The City of Spartanburg Design Review Board

AGENDA

September 2, 2025, at 5:30 P.M.

Meeting Minutes of the Design Review Board (DRB)
Tuesday, August 5, 2025, at 5:30 PM
Dr. TK Gregg Recreation Center

FLOOR PLANS

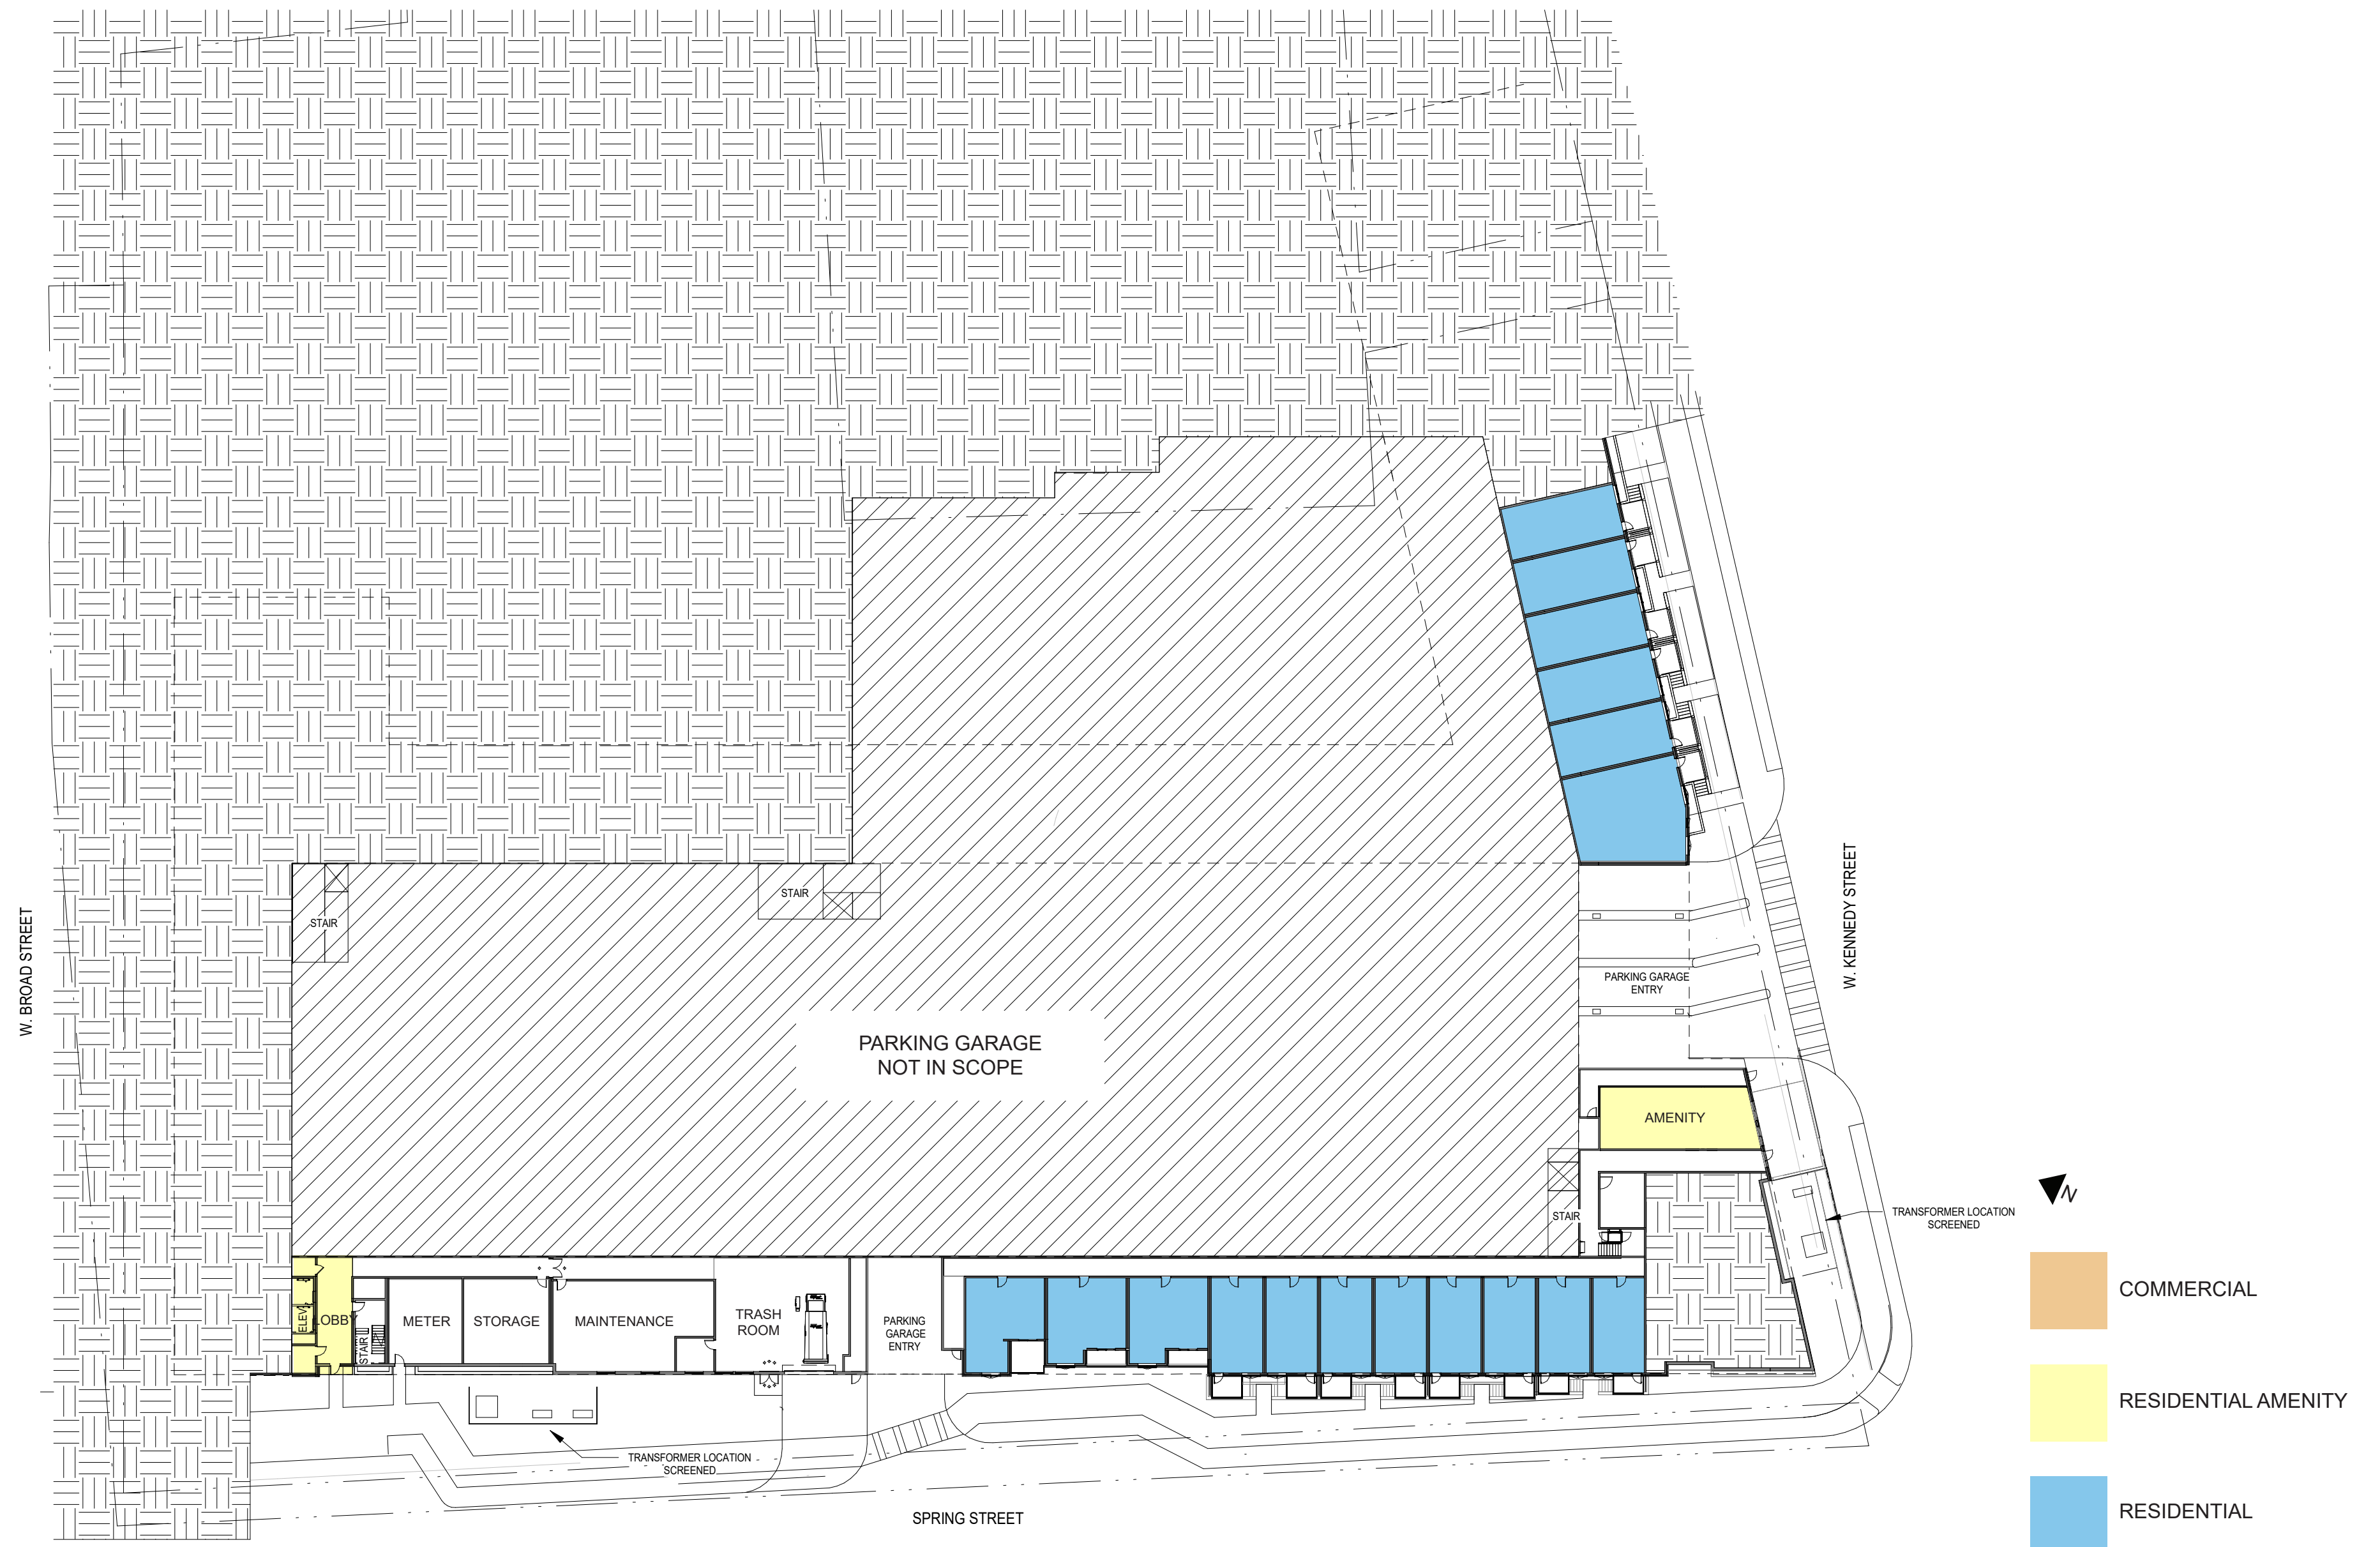
Section 6.4.4.a Blank Wall Length. Minimize Blank Walls: Expanses of blank walls may not exceed 20 feet in length.

Requested Variance: Increase the length of blank walls at 3 specific locations: The trash room and pump room area at Spring St, which has a blank wall of 37’ – 2” and the pool deck area at the corner of Spring St and Kennedy St which has a blank wall of 56’ – 6” on Spring St and 68’ on Kennedy St.

The locations for the trash room and pump room doors are driven by the slope of the site as well as the need to avoid conflicts with other underground utilities such as extensive Duke Energy duct banks. We have located the trash room on one of the few relatively flat areas along the street that will provide a truck with a level surface and adequate overhead clearance which is required to service the trash compactor. This trash room will also serve the County/City Parking Deck, which has no street frontage. We feel it is neither appropriate nor beneficial to the public to have transparent glazing into the trash room or the pump room and thus the doors are all solid metal.

At the walls surrounding the pool deck, we are proposing to provide a treatment of landscaping, trellised plants and dynamic architectural features in lieu of glazing. A sunken seating area is located along Spring St at 4' below the pool deck and is surrounded by a decorative metal screen that functions as both a guardrail and a building façade element. The pool itself will have a transparent enclosure facing Spring St. that will be visible to pedestrians at street level. The pool deck is located on Level 1,
